KEFORD COLLISION AND TOWING JSP 18-31

Public hearing at the request of Keford Collision & Towing for Planning Commission's approval of the Preliminary site plan, Wetland permit, and Storm water management plan. The subject property is currently zoned I-2 (General Industrial) with an associated Planned Rezoning Overlay (PRO) Agreement. The subject property is approximately 7.61 acres and is located on the south side of Grand River Avenue between Taft Road and Novi Road in Section 15. The applicant proposes to use the existing building for an auto body collision repair shop along with an accessory use of car rental services and to install an enclosed storage yard in the rear yard for towed vehicles of up to 160 spaces.

PLANNING REVIEW

CLIENT: KEFORD COLLISION & TOWING
PROJECT: TOPOGRAPHIC SURVEY
SECTION: 15
TOWNSHIP: N
COUNTY: OAKLAND
STATE: MICHIGAN

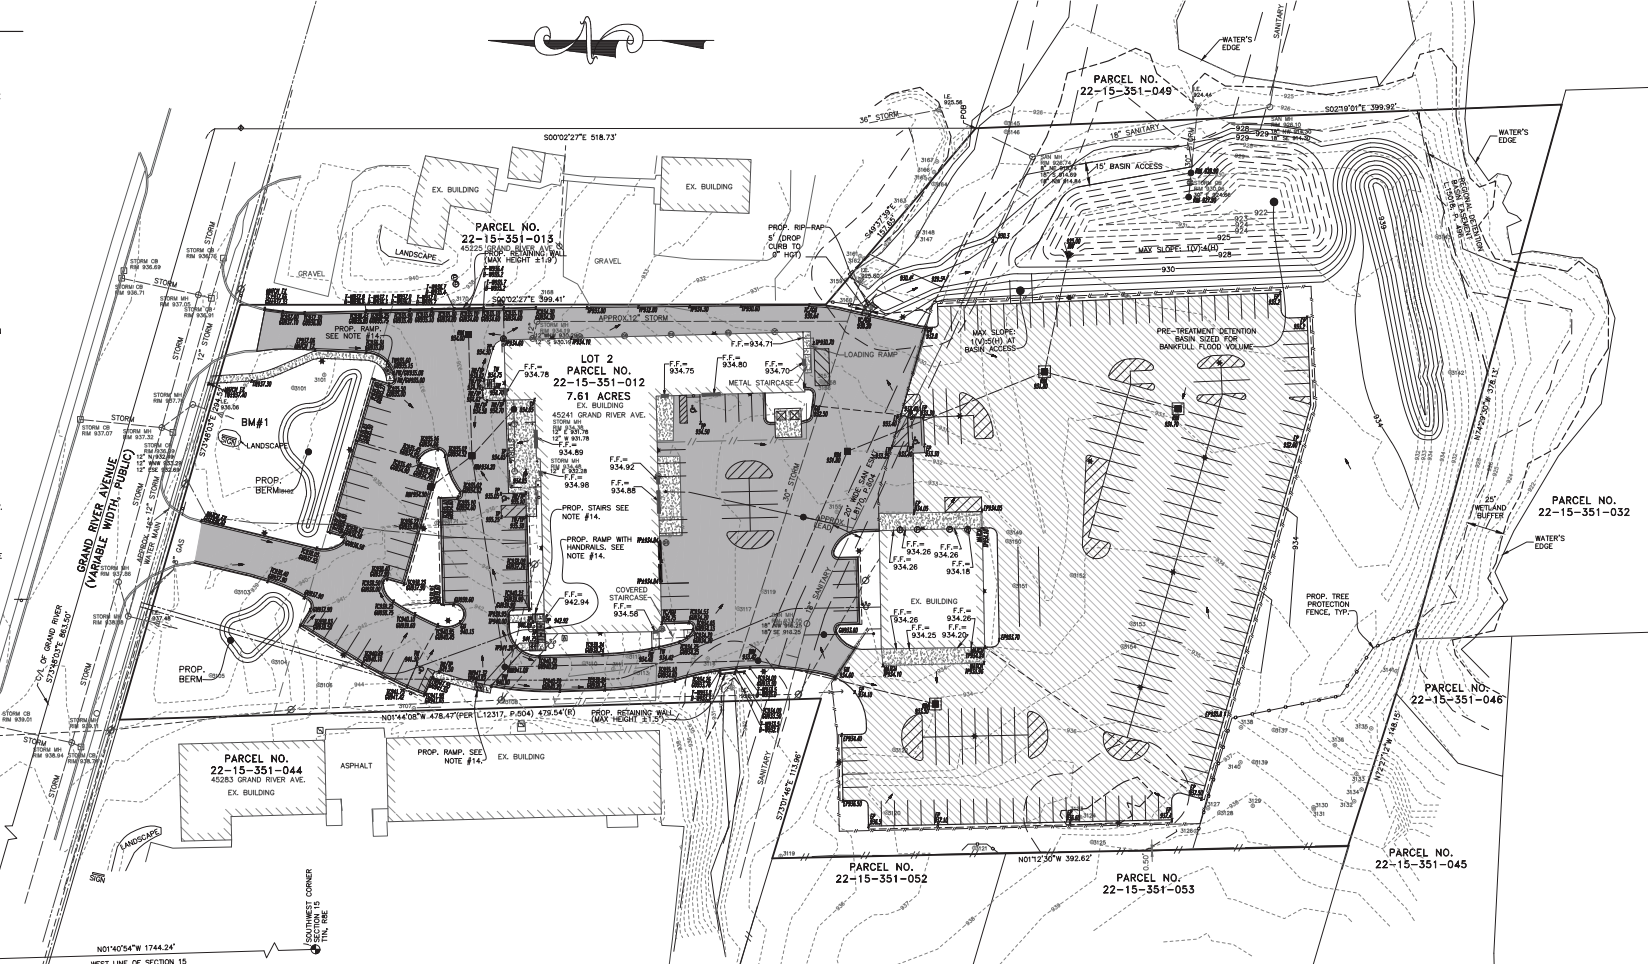
1. The wetland and wetland buffer boundaries indicated on the Plan appear to be approximate. Subsequent site plan submittals shall include the actual, surveyed wetland boundary information that appears to be included on the Wetland Delineation map provided by KME (Figure 2). The wetland flag numbers shall also be provided on the Plan.

This comment has been satisfactorily addressed. This information has been included on the Topographic Survey (Sheet 2).

PRELIMINARY GRADING PLAN
SECTION: 15
45241 GRAND RIVER AVENUE
TOWNSHIP: N
COUNTY: OAKLAND COUNTY
MICHIGAN

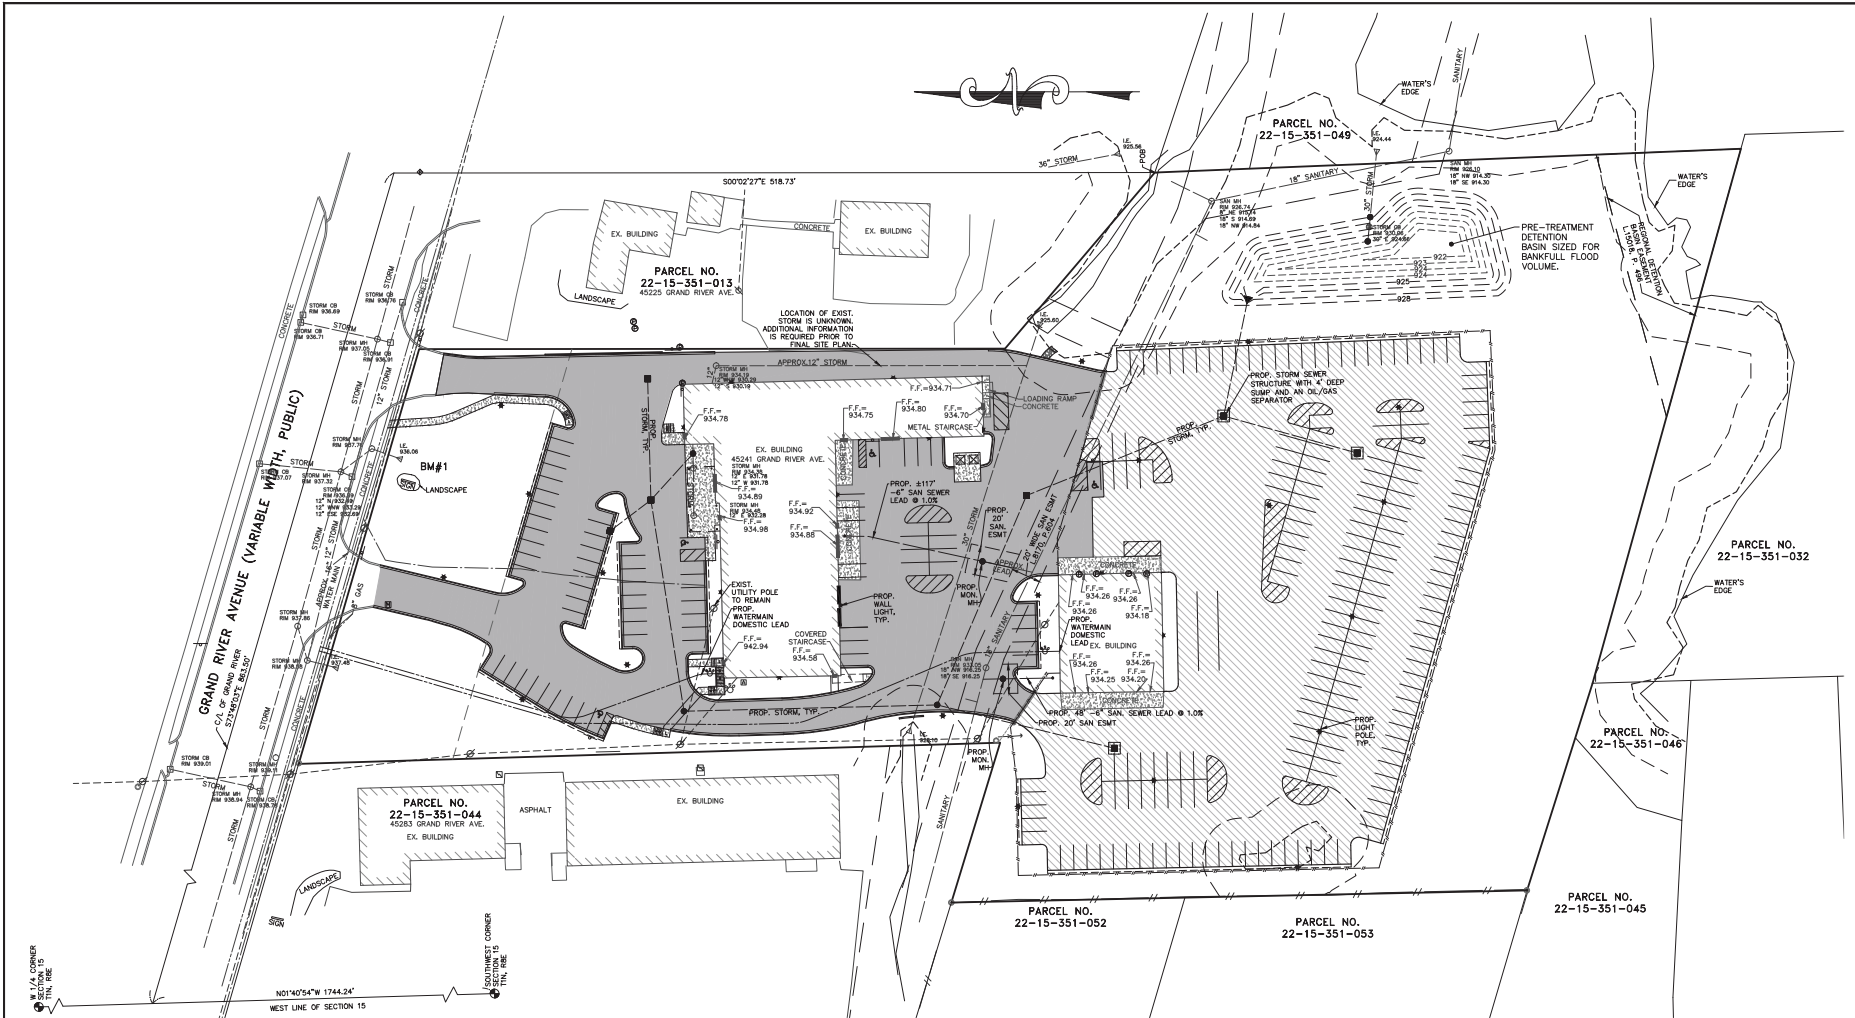
2. It is unclear if the proposed site work will impact Wetland C, however it does not appear likely. The boundaries of Wetland C are not currently shown on Sheet 1. This information should be provided/clarified on subsequent site plan submittals.

This comment has not been addressed. All impacts on the Preliminary Grading Plan (Sheet 3) appear to be permanent, however a Low Prairie Seed Mix is proposed on the Landscape Plan (Sheet L-1). It is not clear where this particular seed mix is proposed to be installed. Please review and revise the Plan as necessary.

This comment has been satisfactorily addressed. This information has been included on the Preliminary Grading Plan (Sheet 3).

This comment has been satisfactorily addressed. This information has been included on the Preliminary Grading Plan (Sheet 3).

L-1

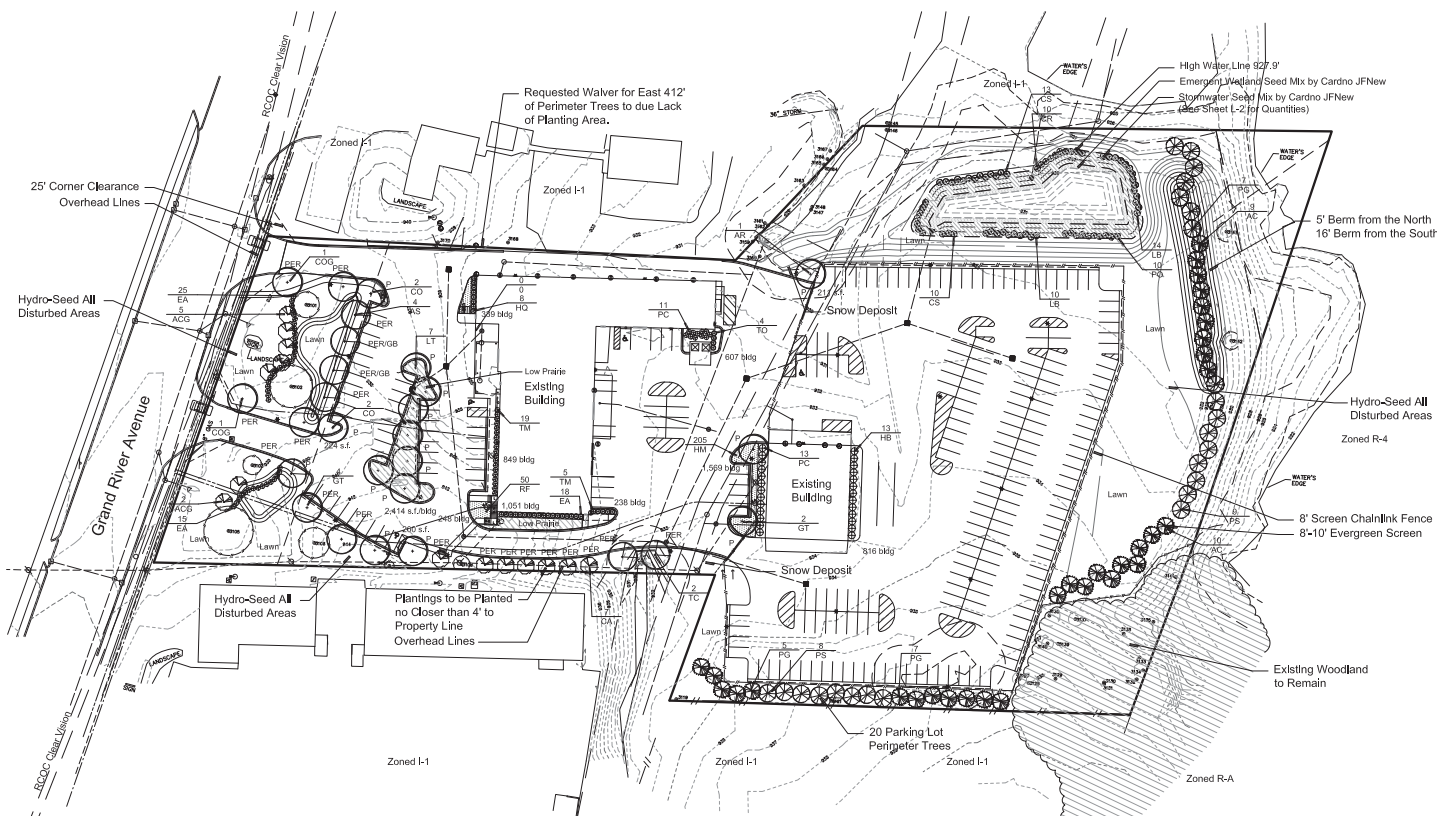
Please copy the above, including the meeting date, to Sheet L-1 in place of the other text regarding waivers.

Please copy the above, including the meeting date, to Sheet L-1 in place of the other text regarding waivers.

- The landscape waivers, including the meeting date, will be shown on Sheet L-1.
- An additional evergreen tree species will be used.
- An irrigation plan will be submitted with Stamping Sets.
